BRIARGROVE SUBDIVISION, PHASE FOUR

APPLICATION NUMBER 10 DATE December 7, 2017

REQUEST Subdivision

DETAIL SITE PLAN

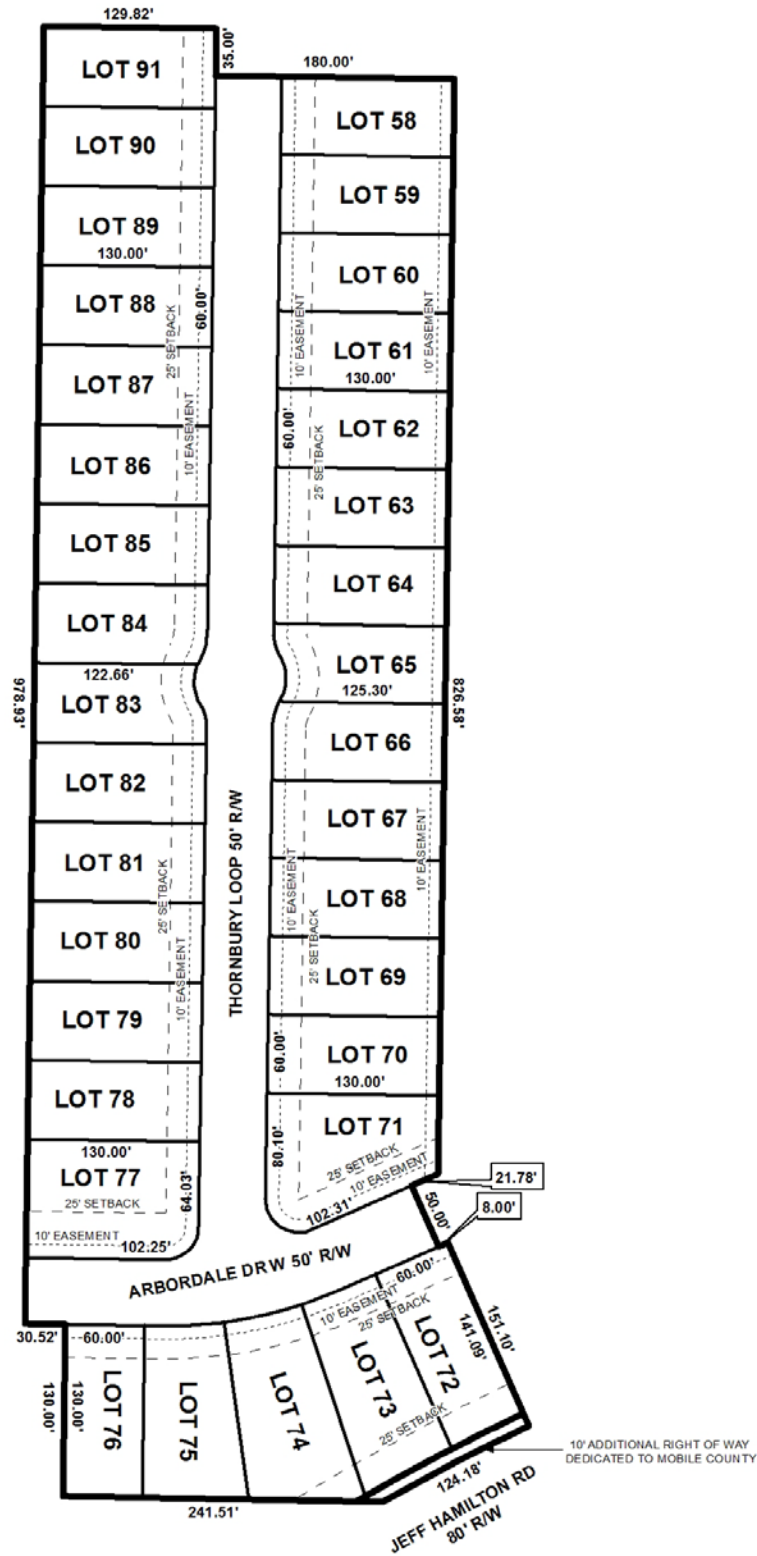
The preliminary plat illustrates the proposed 34-lot, 7.8± acre subdivision which is located on the North side of Jeff Hamilton Road extending to the West terminus of Arbordale Drive West and the South terminuses of Thornbury Loop and Arbordale Loop. The site is within the Planning Jurisdiction and the applicant states that the subdivision is served by South Alabama utilities, water and sewer. The purpose of this application is to create thirty-four (34) legal lots of record from an existing metes-and-bounds parcel.

It should be noted that the original plat illustrated two points of access. While Fire code no longer addresses the number of access points, it is the Planning Commission's responsibility to ensure adequate access. Therefore, no future phases shall be approved unless additional access is provided, as shown on the original submission or the additional access points should be shown in this application for Phase Four.

The site abuts Phase Three and is connected to Thornbury Loop and Arbordale Drive West, both minor streets requiring a 60' right-of-way width. Both streets illustrate compliant 50' right-of-way widths. If approved, the right-of-way widths should be retained on the Final Plat. To the South, Lots 72-76 abut Jeff Hamilton Road, a major street with a 100' right-of-way width requirement. The preliminary plat illustrates an 80' right-of-way width to Jeff Hamilton Road with dedication to provide 50' from the centerline. If approved, the right-of-way should be retained on the Final Plat, adjusted for dedication.

The preliminary plat illustrates building setback lines along Thornbury Loop, Arbordale Drive West and Jeff Hamilton Road. If approved, the 25' minimum building setback along all street frontages should be retained on the Final Plat.

In accordance with Section V.D.2. of the Subdivision Regulations, the proposed lots each exceed the 7,200 square foot minimum lot size requirement for lots served by public water and sewer systems. The lot size information for each lot is depicted in both square feet and in acres on the preliminary plat and should be retained on the Final Plat, if approved.

As a means of access management, a note should be placed on the Final Plat, if approved, stating that each proposed lot is limited to one curb cut, with the size, design and location of the curb cut to be approved by Mobile County Engineering and conform to AASHTO standards. Lots 72 and 73 should be denied direct access to Jeff Hamilton Road.

- 1) No future phases shall be approved unless additional access point to Jeff Hamilton Road is included;
- 2) Submission of a new master plan depicting a second point of access to Jeff Hamilton Road prior to the signing of the Final Plat;

- 4) Retention of the 80' right-of-way width to Jeff Hamilton Road with dedication to provide 50' from the centerline;
- 5) Retention of 25' minimum building setback line along all street frontages;

- 6) Retention of the lot size information in both square and in acres on the Final Plat, adjusted for dedication;
- 7) Placement of a note on the Final Plat stating that each proposed lot is limited to one curb cut, with the size, design and location of the curb-cut to be approved by Mobile County Engineering and conform to AASHTO standards;

- 8) Placement of a note on the Final Plat stating that lots 72 and 73 are denied direct access to Jeff Hamilton Road;
- 9) Placement of a note on the Final Plat stating that any lots which are developed commercially and adjoin residentially developed property must provide a buffer, in compliance with Section V.A.8. of the Subdivision Regulations;
